RAI Volume 3, Chapter 2.2.1.4.1, First Set, Number 3:

Clarify the technical basis for the values used to represent the tephra volume for the volcanic eruption modeling case.

RAI Volume 3, Chapter 2.2.1.4.2, First Set, Number 1:

Figure 1. Probability Distribution and Statistics for Erupted Tephra Volume

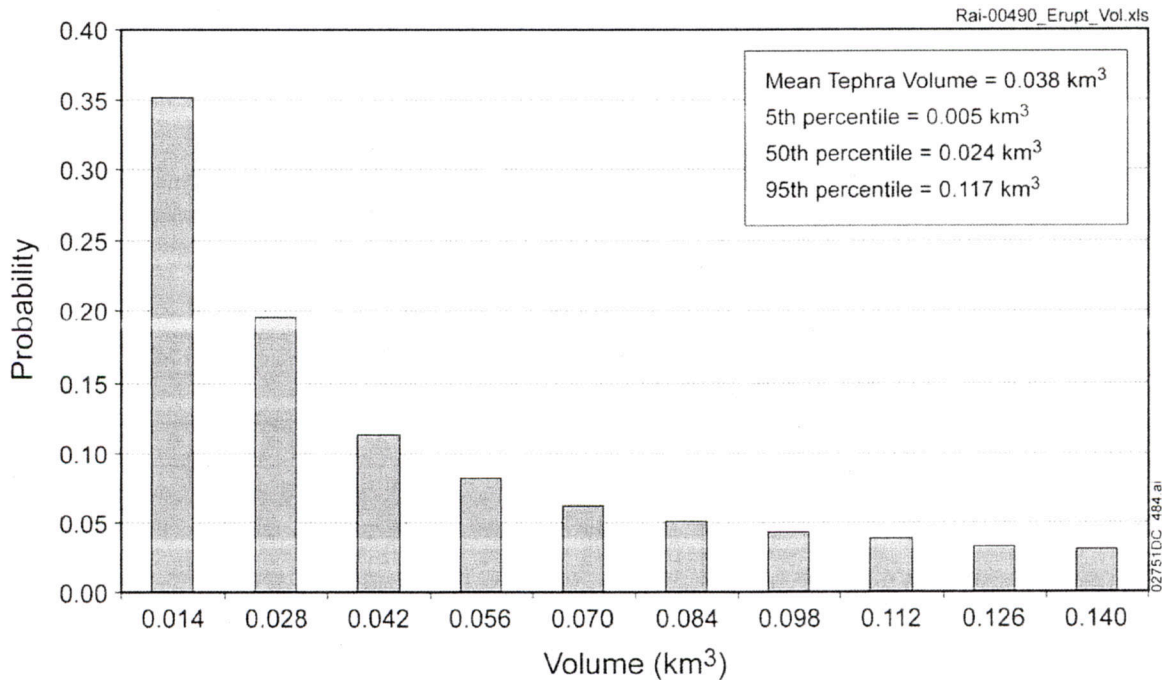
Basis: The SAR provides an estimated range for the total volume of past eruptive events of 0.004 to 0.12 cubic kilometers (Table 2.3.11-2). The SAR also states that the tephra volume is expected to be significantly less than the total volume (i.e., tephra volume estimated for the Lathrop Wells is 0.07 cubic kilometers versus 0.12 cubic kilometers for the total volume – page 2.3.11-50). Implementation of the eruptive modeling case in the TSPA has minimum and maximum values of 0.004 and 0.14 cubic kilometers for use in developing inputs for the ASHPLUME code. These minimum and maximum values reflect the total volume not the tephra volume. Only the latter is significant to the dispersal of radionuclides entrained in tephra. This information is needed to determine compliance with 10 CFR 63.114.

A distribution of tephra volumes equivalent to that used in the TSPA volcanic eruption modeling case was developed for this response using the equations that constrain eruptive mass flux (SNL 2007b, Equations 8-1a and 8-1b) and the probability distributions used for eruptive power, duration, and tephra density. The resulting tephra volume distribution and associated statistics are shown in Figure 1. Because eruption duration and power are sampled using a log-uniform distribution, the erupted tephra volume shown in Figure 1 follows a similar distribution. As shown in the figure, values in the upper end of the range of tephra volumes have a relatively low probability of occurring. The figure also shows that the mean value of tephra volume is 0.038 km^3 and half of the sampled values are less than 0.024 km^3 . These values reasonably represent the uncertainty in tephra volume and are consistent with the values of total volume shown in SAR Table 2.3.11-2.
